**Report: Final TAB Report  
Function: Test, Adjust, & Balance  
Date: 8/30/2022**

**PROJECT  
08-08 CULVERS - ROGERS, AR**

## 08-08 CULVERS - ROGERS, AR

**Issue Name :** HIGH PRIORITY - RTU1 "Smoke Alarm" status

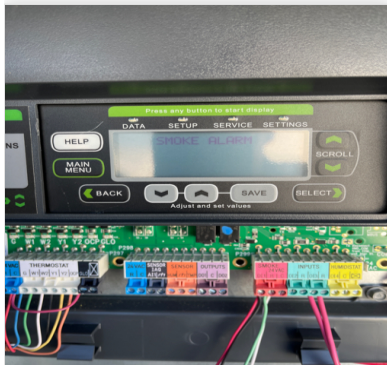
**Description :** Responsibility - MC RTU1 is showing a "Smoke Alarm" status and is not running normally as a result. Resetting the unit has not resolved. The unit is still able to be put into test mode with cooling. Unit has already been balanced.

- **08/12/2022 National TAB - Jacob Davidson**
  - Attached photo of prodigy board screen.

**Issue Name :** HIGH PRIORITY - RTU1 and RTU2 humidistat not wired

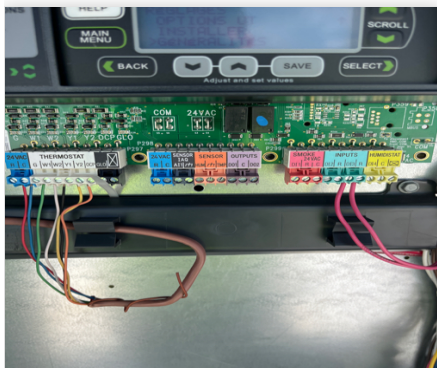
**Description :** Responsibility - MC Humidistat for each unit has not been landed to unit. I spoke to the MC and this is still on backorder currently.

**Issue Name :** HIGH PRIORITY - RTU1 and RTU2 OCP wiring

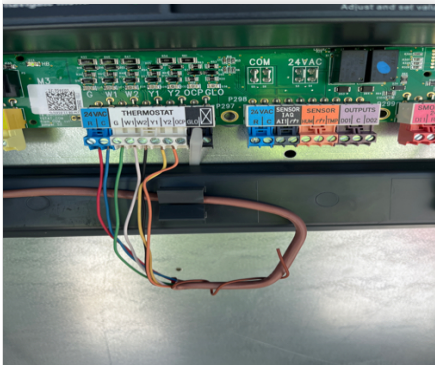
**Description :** Responsibility - MC Unit not wired for occupancy. This is needed in order for the Economizer to open and function. MC assisted and we have jumped R to OCP in order to open the economizer for our purposes.

**Issue Name :** HIGH PRIORITY - RTU2 prodigy board malfunctioning

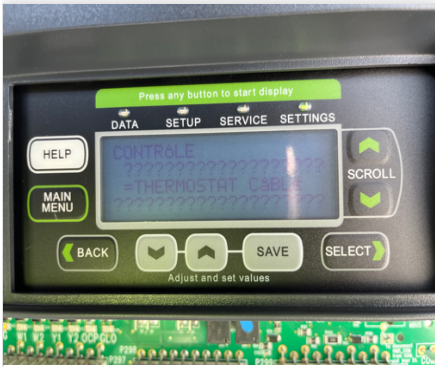
**Description :** Board displays options in another language and has mostly question marks on display. Unable to adjust language or change settings.

- **08/10/2022 National TAB - Jacob Davidson**
  - After troubleshooting with LENNOX, we determined that the unit needs a new board, which will be covered under warranty. MC and GC have been made aware.
